591, 593 COBBITTY ROAD &
1 FRESHWATER DRIVE, COBBITTY
(PRECINCT 2A STAGE 1 &
TRANCHE 5a STAGE 1)
ROAD & DRAINAGE DESIGN

ISSUED FOR SUBDIVISION WORKS CERTIFICATE

WORKS AS EXECUTED
WORKS AS EXECUTED INFORMATION SHOWN IN RED.
DATE: 15/09/2025

ENGINEERING PLAN
SHEET 07

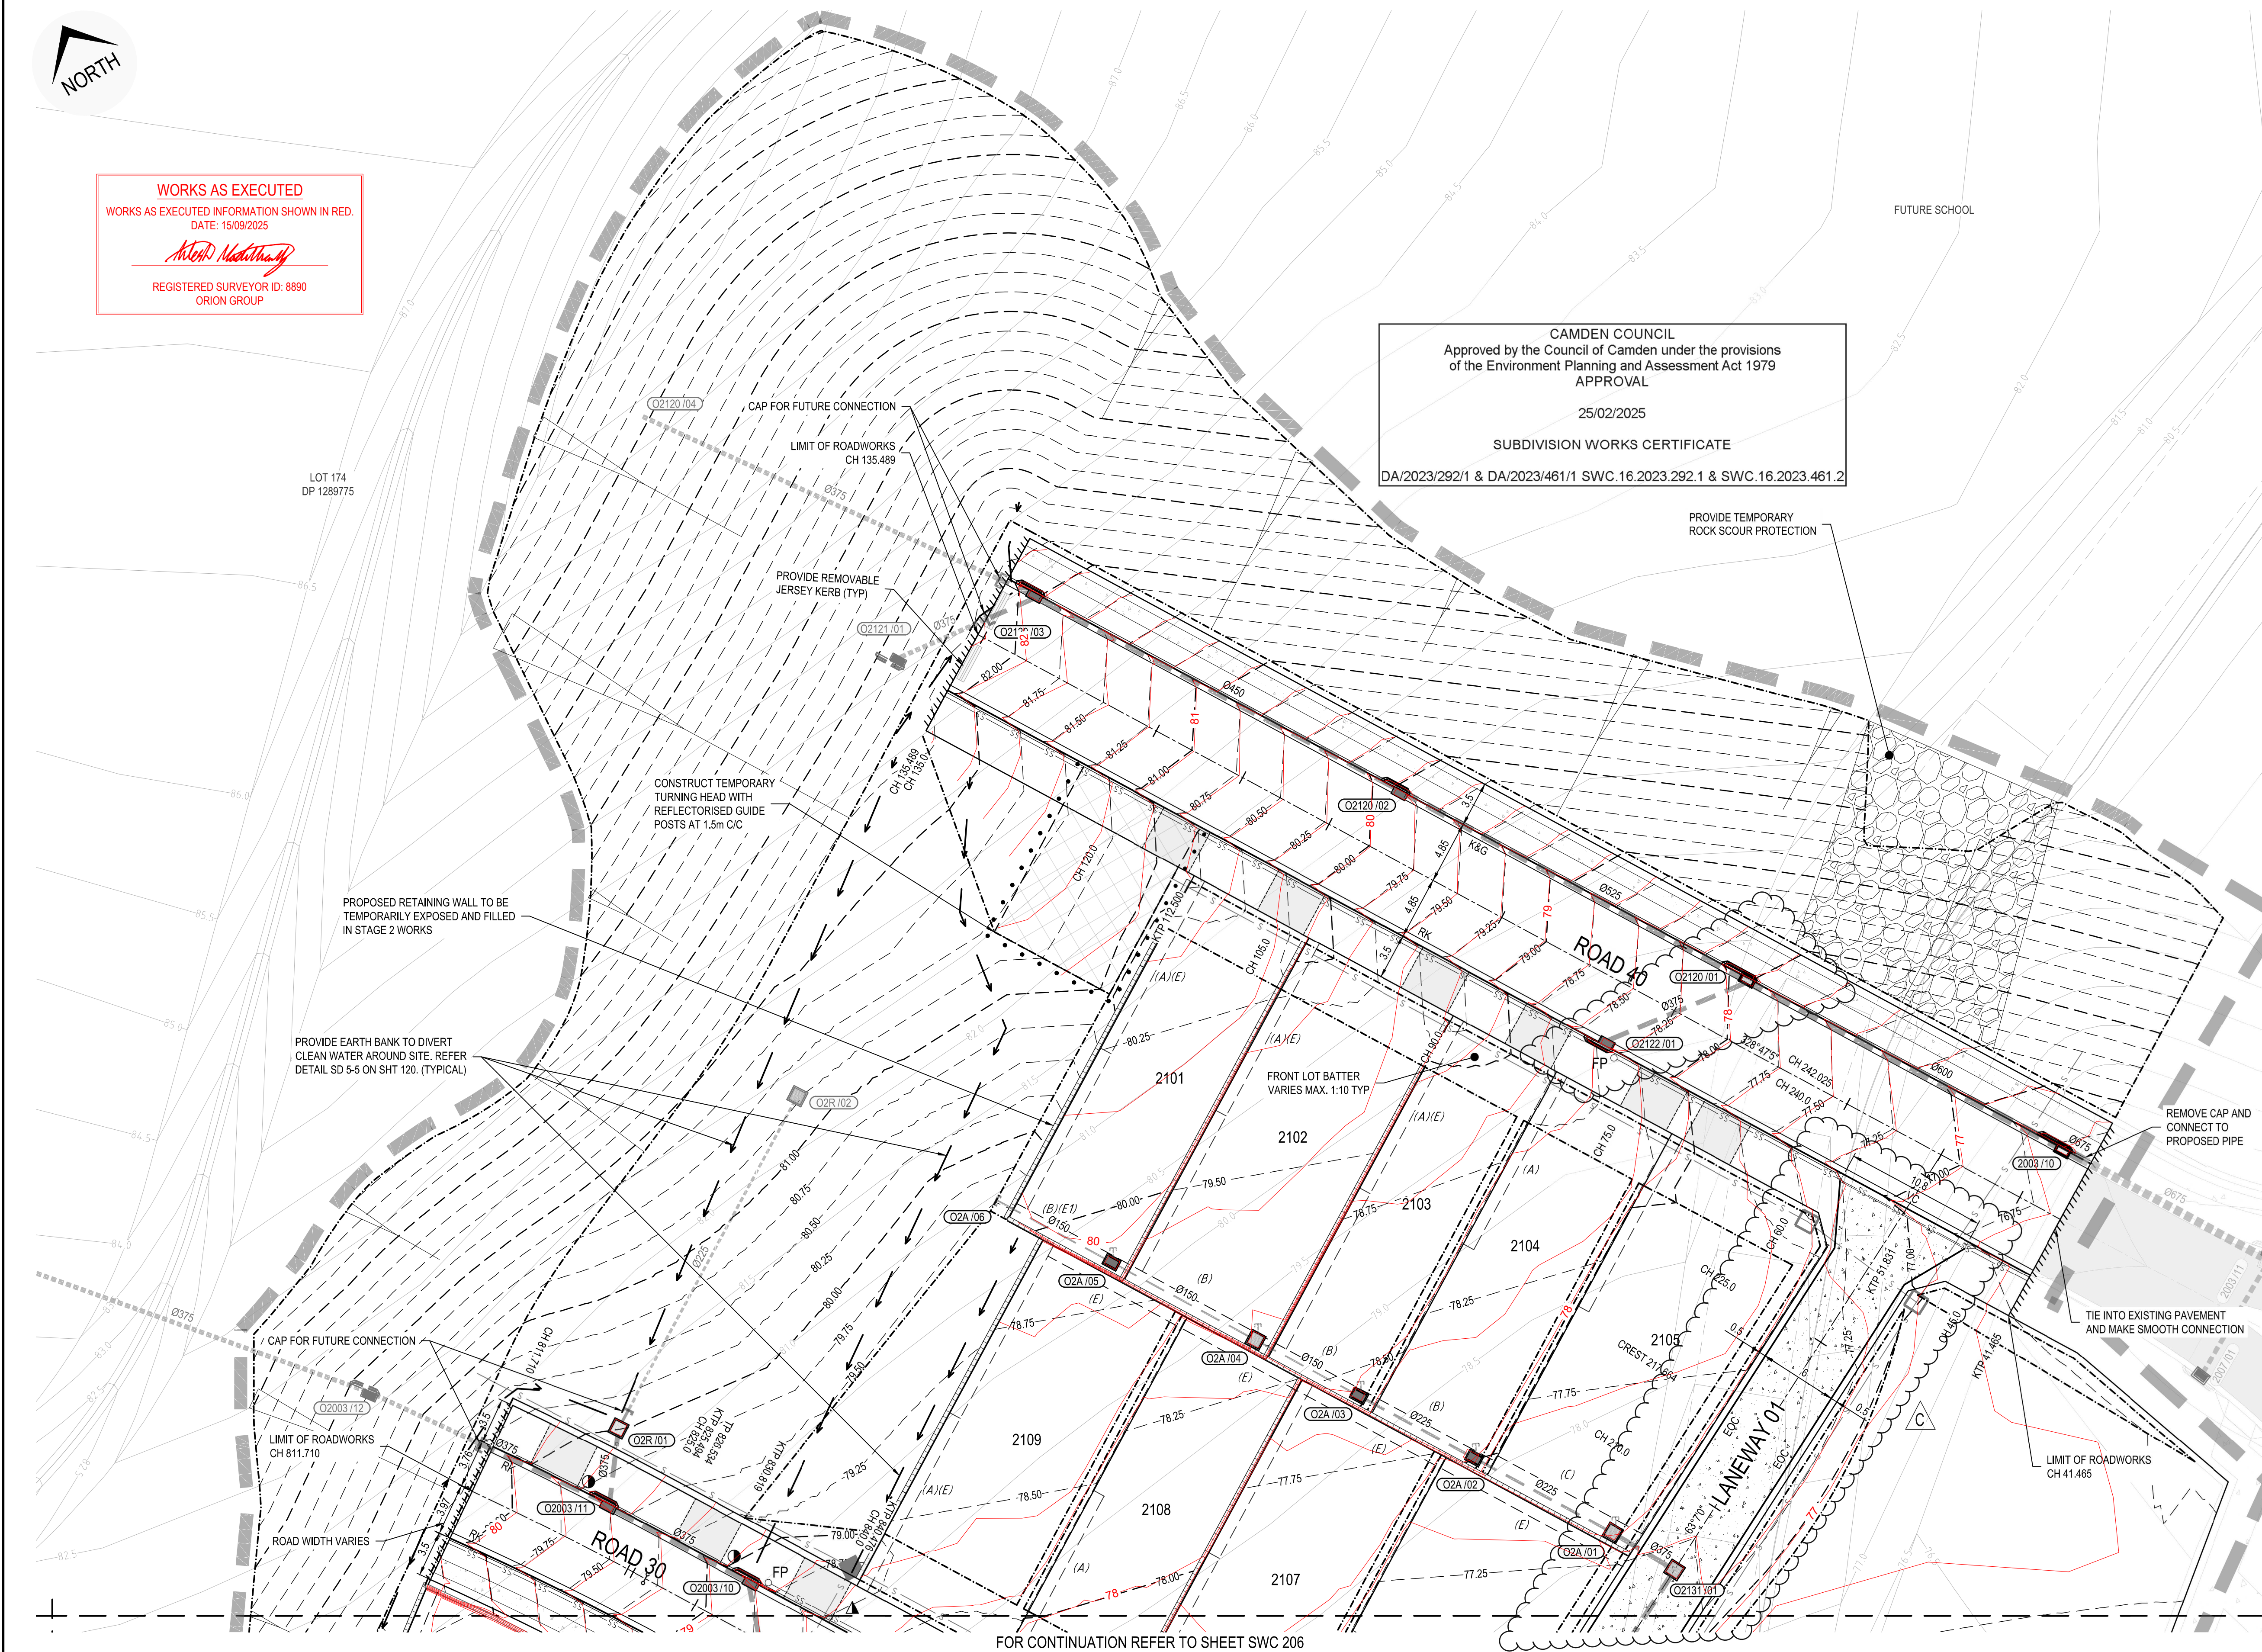
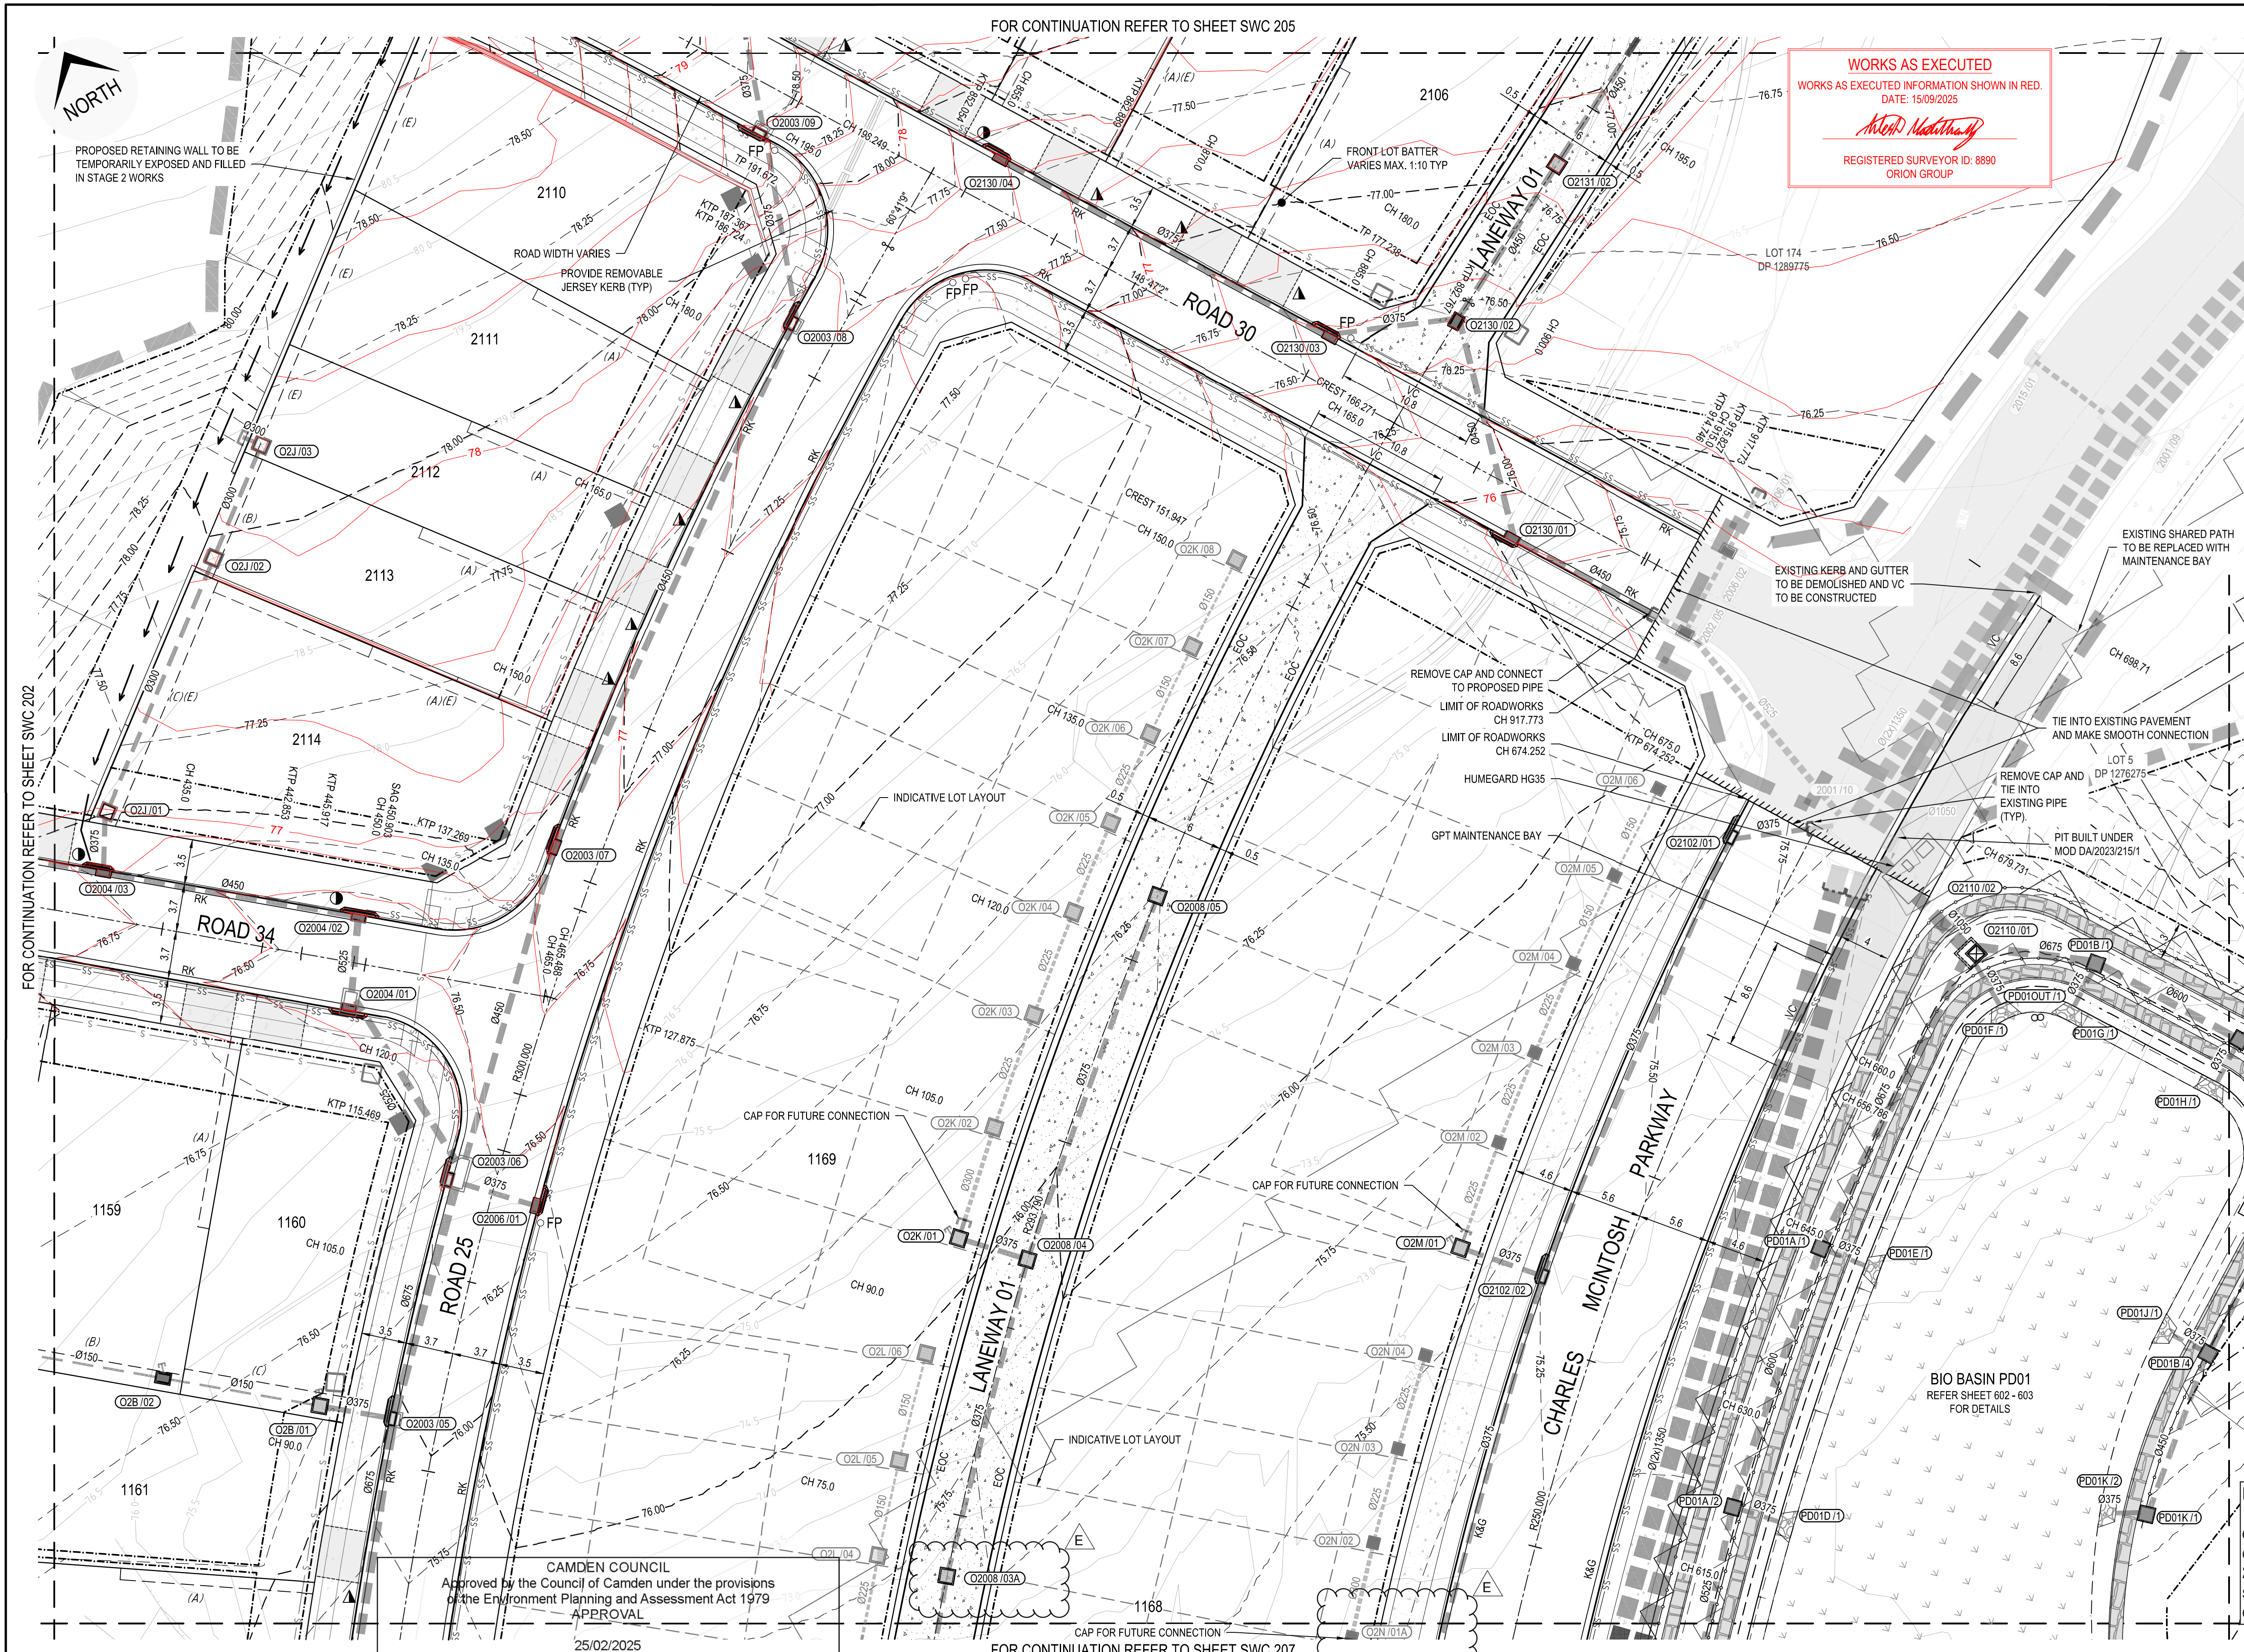
*PRAM RAMP CHANGED TO SQUARE WINGS
